STAFF RECOMMENDATION

107 South 13th Street

May 20, 2020

Application: New Construction—Addition; Partial Demolition

Figure 5 (top) shows the area to be altered and Figure 6 (below) shows the revised roof form.

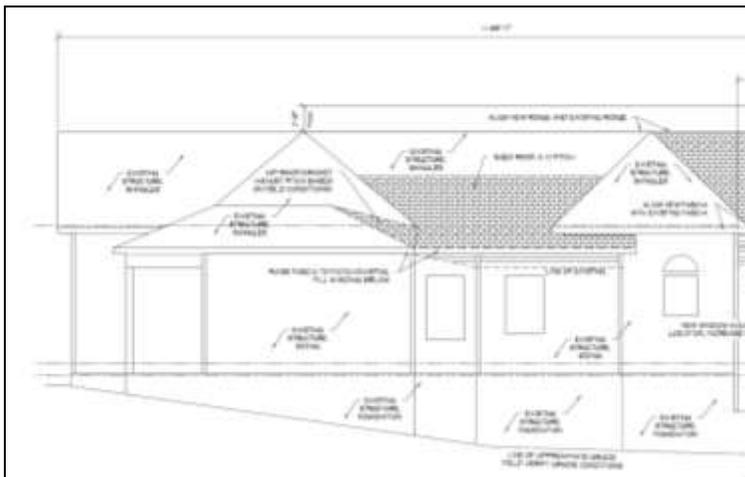
Demolition: The applicant intends to alter part of the roof of the existing house which is causing water issues and to alter a rear addition, both of which are considered partial demolition. On the historic house, the applicant intends to alter two overlapping low slope sheds on the right side (Figures 5 &6). One new shed will cover this area. Staff finds that this meets the design guidelines because this roof form is likely not be original and because the new roof form is needed to keep the water draining properly off the roof.

Staff finds that the proposed partial demolition meets Section III.B.2. for appropriate demolition and does not meet section III.B.1 for inappropriate demolition.

02 DEMOLITION PLAN

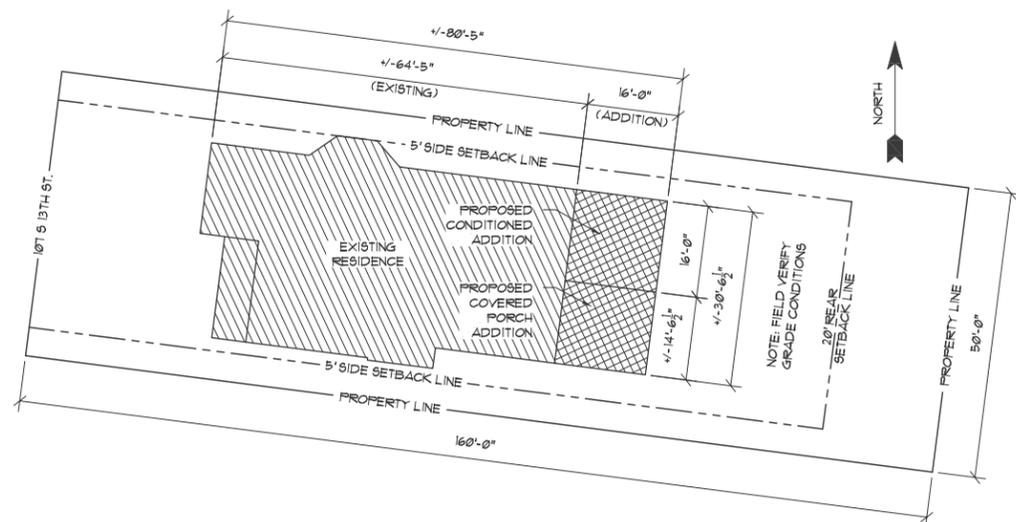
The applicant also intends to alter a rear portion of the house that dates to 1998. The partial demolition of the 1998 portion of the house meets the design guidelines because it is not a contributing part of the house. Lastly, the applicant intends to alter two window openings on the existing addition, which is appropriate because they are not historic window openings.

01 SITE PLAN

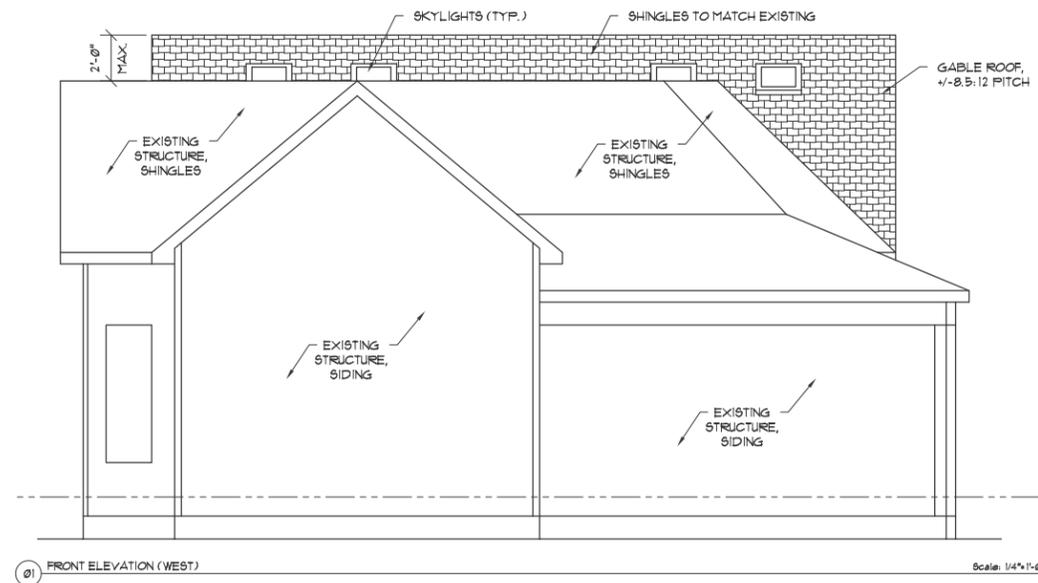
Setback & Rhythm of Spacing: The addition meets all base zoning setbacks. It will be about eleven feet (11') from the right property line and ten feet (10') from the left property line. It will be over fifty feet (50') from the rear property line.

Appurtenances & Utilities: No changes to the site's appurtenances were indicated on the drawings. The location of the HVAC and other utilities was also not noted. Staff recommends that the HVAC be located on the rear façade, or on a side façade beyond the midpoint of the house.

Staff finds that the addition's setback meet Sections II.B.3. and II.B.10. of the design guidelines.

1. Staff approve the final details, dimensions and materials of windows and doors prior to purchase and installation;
2. Staff approve the roof color, dimensions and texture; and
3. The HVAC shall be located behind the house or on either side, beyond the mid-point of the house.

EXTERIOR
 ELEVATIONS

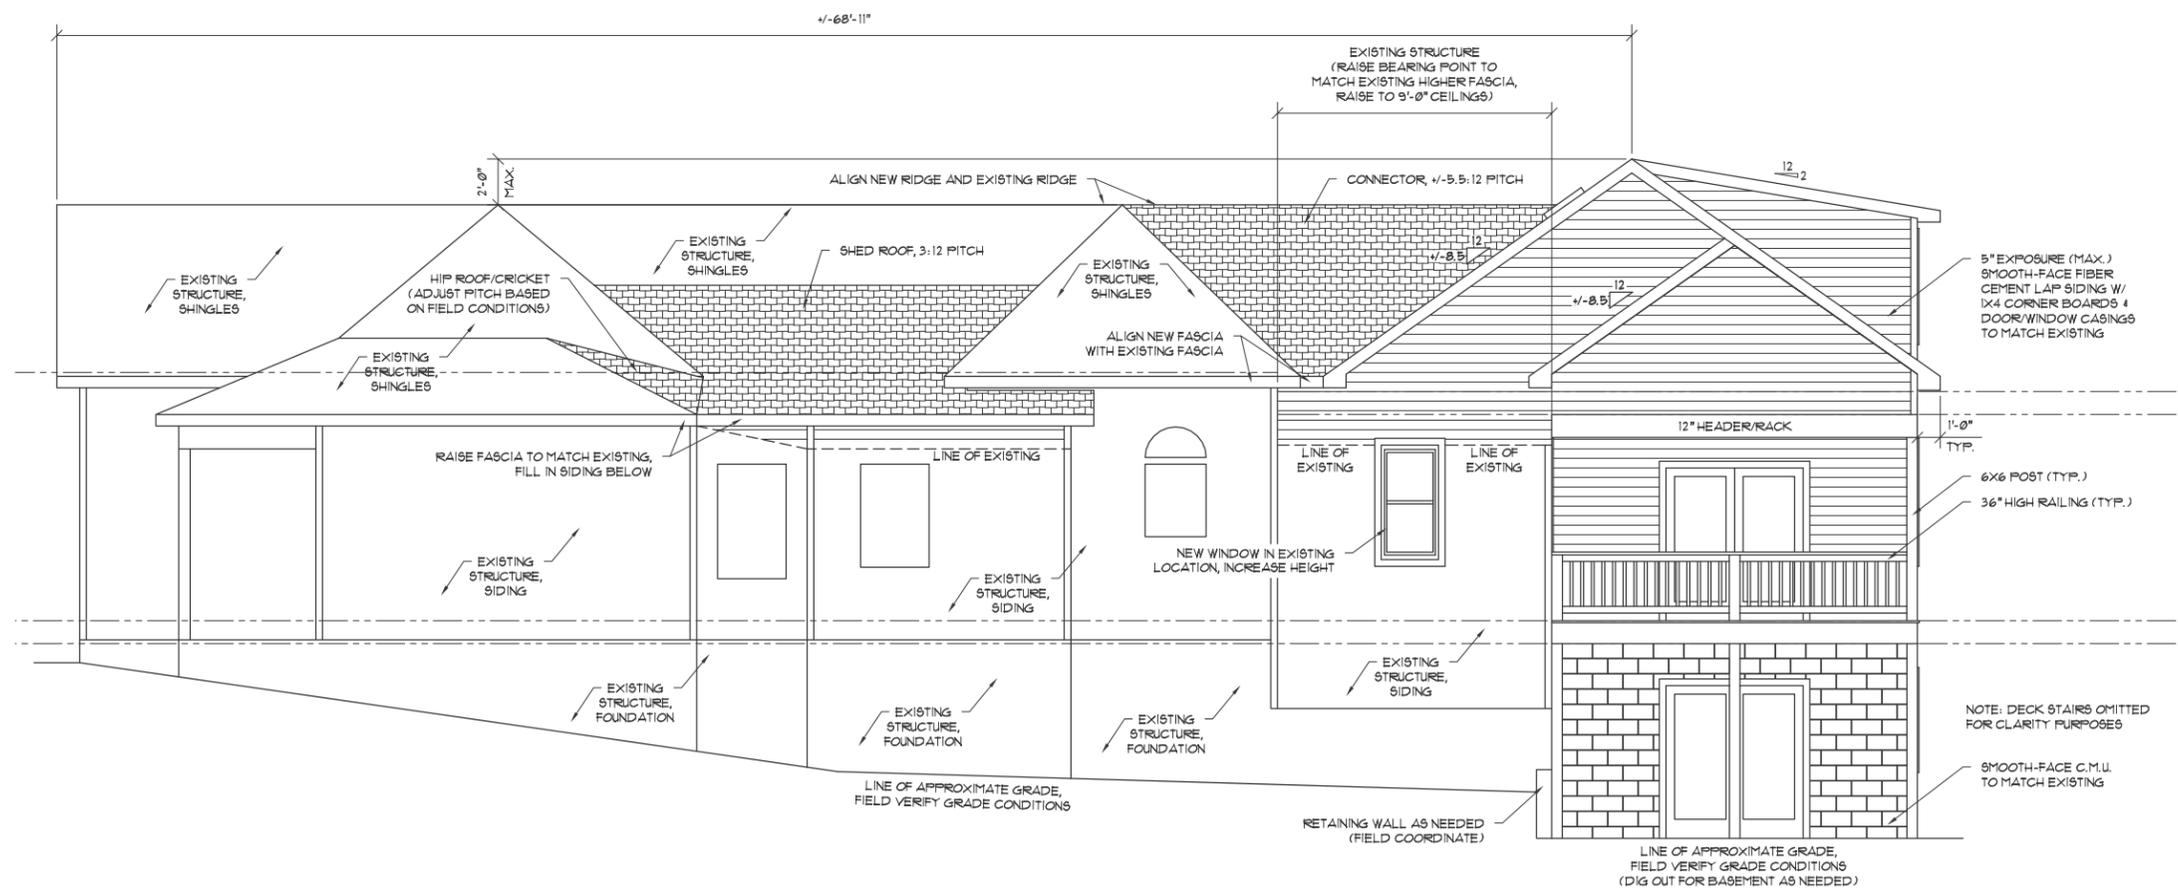
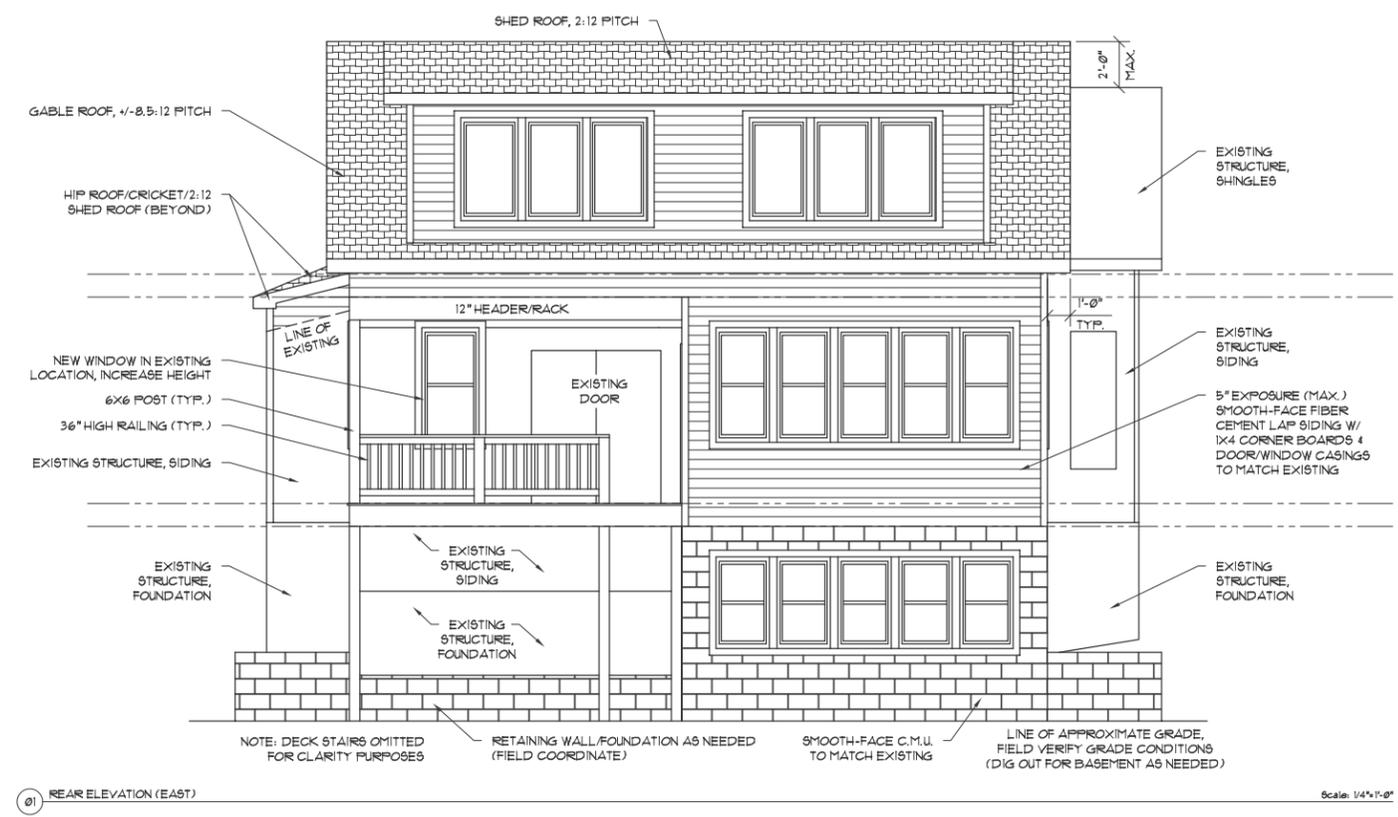
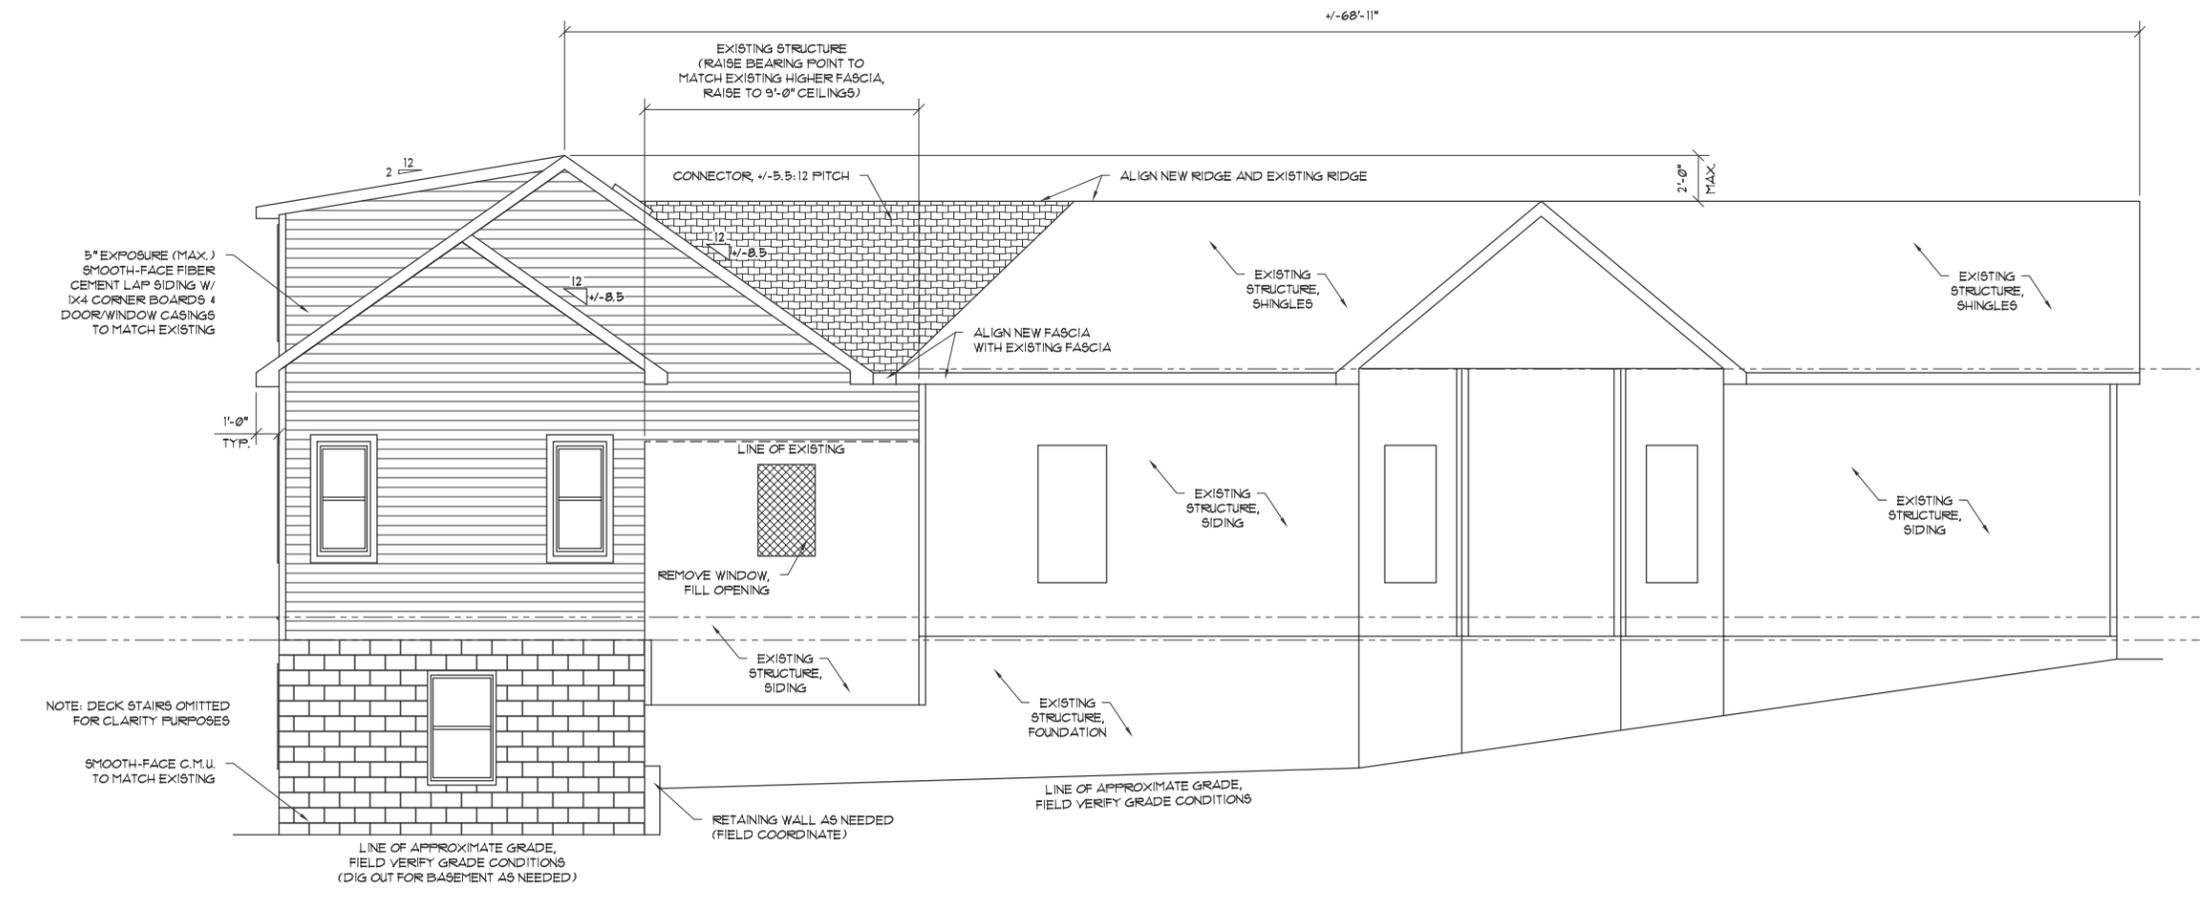
The addition will be two feet (2') taller than the historic house, which meets the design guidelines. The taller portion of the addition does not occur until almost sixty-nine feet (69') back from the front of the house, which will help to decrease its visibility from the street. Because of the slope of the site down towards the alley, the addition does gain a basement level at the rear.

Roof form: As mentioned under partial demolition, the project involves altering two overlapping sloped roofs on the historic house to be one shed roof form. Staff finds this to meet the design guidelines. The roof form of the addition will be gable with an 8.5/12 slope with a 2/12 shed roof dormer on the rear.

Proportion and Rhythm of Openings: The applicant intends to alter two window openings on the existing addition, which is appropriate because they are not historic window openings. The windows on the proposed addition are all generally twice as tall as they are wide, thereby meeting the historic proportions of openings. There are no large expanses of wall space without a window or door opening.

Staff finds that the addition's height and scale to meet Sections II.B.1., II.B.2., and II.B.10. of the design guidelines.

Staff finds that the proposed roof forms meet Sections II.B.5. and II.B.10. of the design guidelines.

Staff finds the addition's proportion and rhythm of openings to meet Sections II.B.7. and II.B.10. of the design guidelines.
